DATE: March 2, 2022
 AGENDA ITEM # 2

TO: Design Review Commission
FROM: Steve Golden, Senior Planner
SUBJECT: SC21-0023 – 959 Altos Oaks Dr

Re: Community Development Department
One North San Antonio Road
Los Altos, California 94022
(Yamamura - Green Residence)
Studio S Squared Job #20033
Plan Check No: SC21-0023

DRC PRIVACY PLANTING STUDY

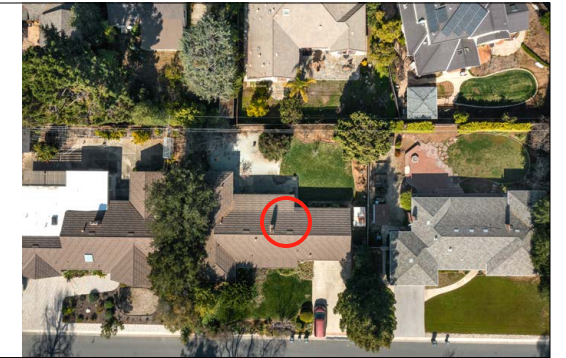
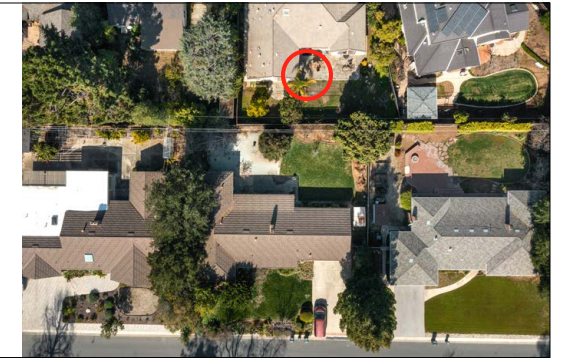
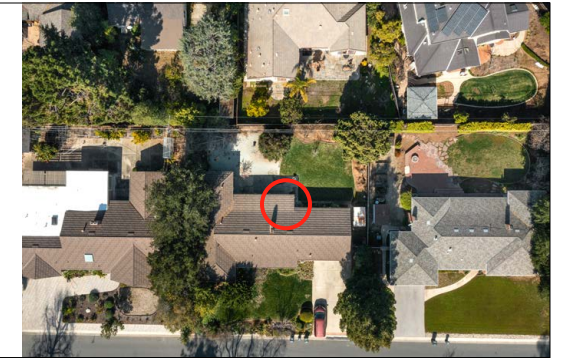
1. Reduce the first and second story plate heights a minimum 6"
 - a. We have reduced the first and second story plate heights 6" each.
2. Provide a streetscape view showing relationship with adjacent residences with accurate plate heights
 - a. We have added a streetscape view showing the relationship with adjacent residences.
3. Provide more detailed views from the neighbor's patio back to the proposed residence and from second story windows to rear patio

- a. We have provided digital and photographic views from the neighbor's patio back to the proposed residence and from the second story windows to the rear patio.
4. Further development of landscape plan details with mature plant heights shown on the plans
- a. The Landscape Plan has been further studied and mature heights have been added to the landscape plan. The privacy planting has also been modeled in 3D.
